Westinghouse Electric
Company, LLC

DCP/NRC1489
Project 711

SUBJECT: Transmittal of Westinghouse Responses to Requests for Additional
Information (RAIs) for AP1000 Pre-Certification Review

"Westinghouse Responses to Requests for Additional Information (RAIs)
for AP1000 Pre-Certification Review"

Figure RAI P68-1 - 2-Inch Cold Leg Break: Core Void Profile

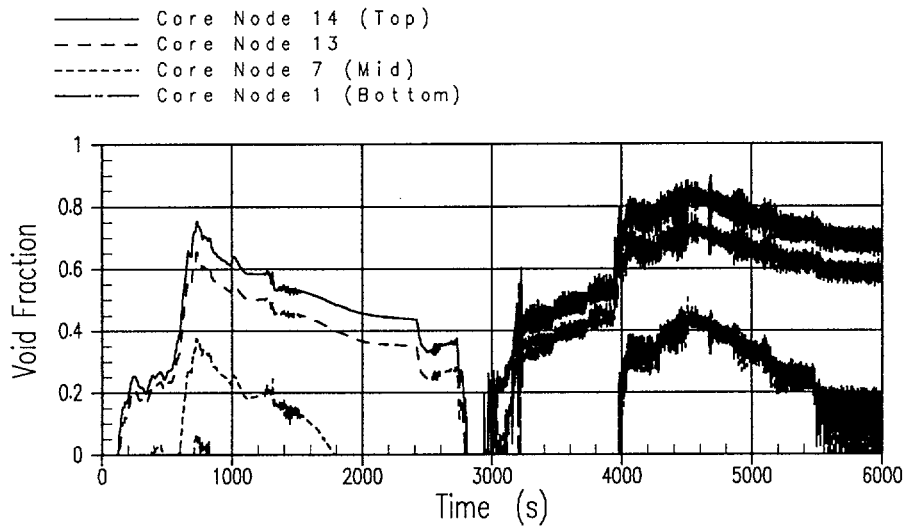
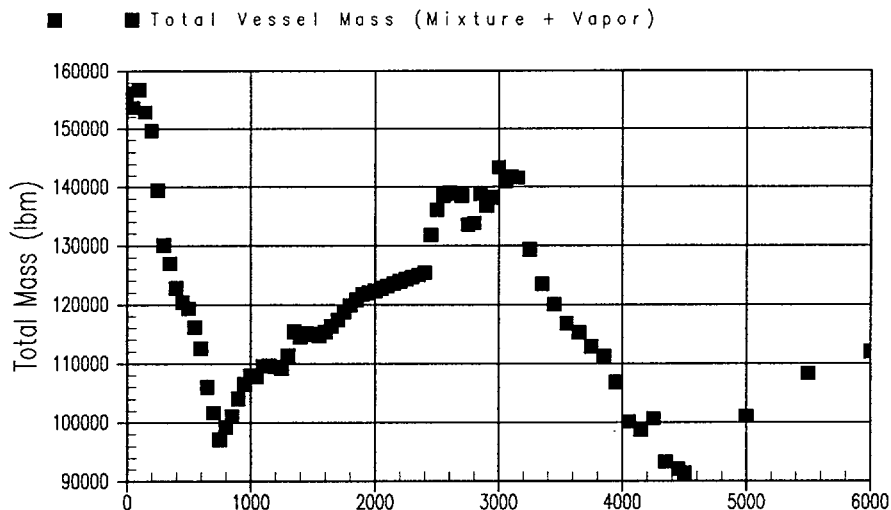
The NRC staff has completed a preliminary analysis of small break LOCA at AP1000 using RELAP5. For a postulated 2-inch cold leg break we calculate core void fractions at the top of the core to be in excess of 90%. These results will be compared to the analysis of the same break size by Westinghouse in WCAP-15612 using the NOTRUMP code. One ADS4 valve was assumed to fail closed as in the NOTRUMP analysis. Decay heat at 1.2 times the 1973 ANS standard was assumed. The containment pressure was set to atmospheric. So that we may continue to compare the results between the two computer codes, please provide the NOTRUMP prediction of core voiding for the 2-inch cold leg break size including the top of the core and intermediate locations. Provide the calculated reactor vessel steam plus water mass as a function of time. Provide the calculated core void fractions and reactor vessel steam plus water mass for the inadvertent ADS opening and double ended DVI line break analyzed using NOTRUMP in WCAP-15612.

As requested, the core void profiles and reactor vessel masses for the 2-inch cold leg break, Inadvertent ADS actuation, DVI line break (w/ containment pressure = 14.7 psia) and the DVI line break (w/ containment pressure = 25.0 psia) documented in WCAP-15612 (Reference RAI P68-1) are provided in the attached figures. The top core node void fraction (Core node 14) observed for the NOTRUMP 2-inch cold leg break simulation approached but did not exceed 90%. In addition to the top core node, void fractions are also provided for Core node 13, the core mid-plane (Core node 7) and the core bottom (Core node 1).
